# DESIGN EXCELLENCE ADVISORY PANEL RECOMMENDATIONS

**Address** 5 Uhrig Road, Lidcombe

**Date** 27<sup>th</sup> February, 2020

Application Number	DA/739/2019
Assessing Officer	Brad Roeleven
Applicant/Proponent	JQZ Ten Pty Limited
Architect and Registration Number	Phillip Rossington – BVN – Reg No: 7151 Adrian Mignot – BVN
Urban Designer	
Landscape Architect	Mike Barnett – Arcadia
Planner	
Others in attendance	Jeremy Hung – JQZ

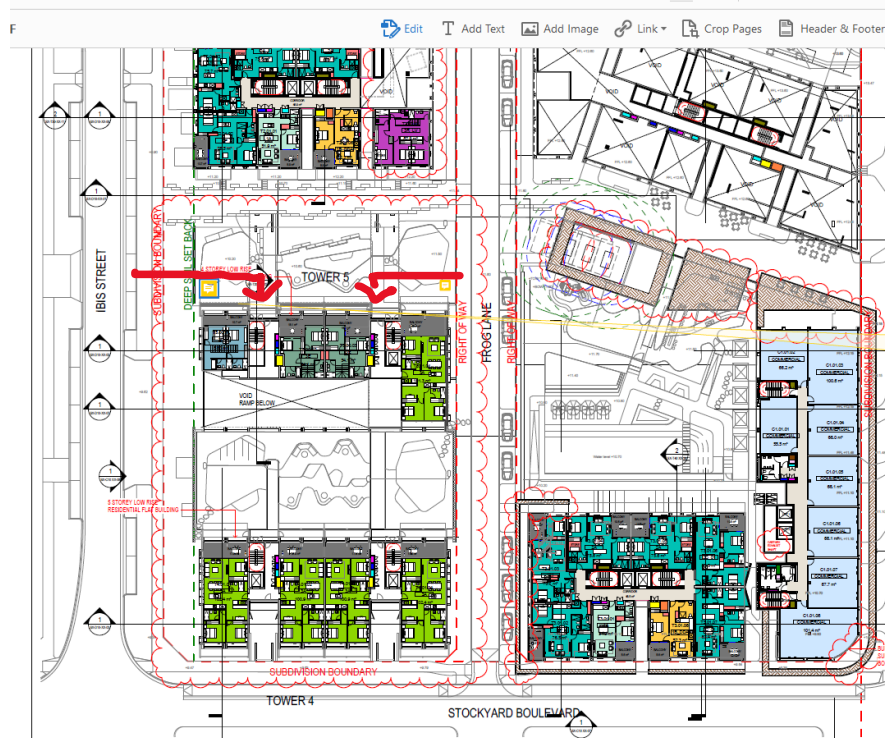
- While the Panel can appreciate the efforts to improve the public domain outcomes, it is of concern that CGI imagery submitted gives a misleading impression of the spatial qualities of the civic place created between developments either side of Uhrig Road. The image below suggests a space with pedestrian links, landscape and generous public open space but that view would only be possible from the centre of the carpark of the 5 Uhrig Rd site opposite, over 20m back from the footpath along the street.

- As noted above the opportunity to provide more accurate depiction of the Uhrig Rd civic realm has not been taken by the Applicant. The suggestion of a good streetscape outcome that can be complementary to both sites either side of Uhrig Rd will only be recognised if such views can be substantiated as realistic. Furthermore, this image does not depict the significant tree canopy implied by the landscape plans, and this should also be accurately coordinated. It is suggested that further views be generated at eye level at the junctions of the public through-site link with Uhrig Road and Ibis Street.
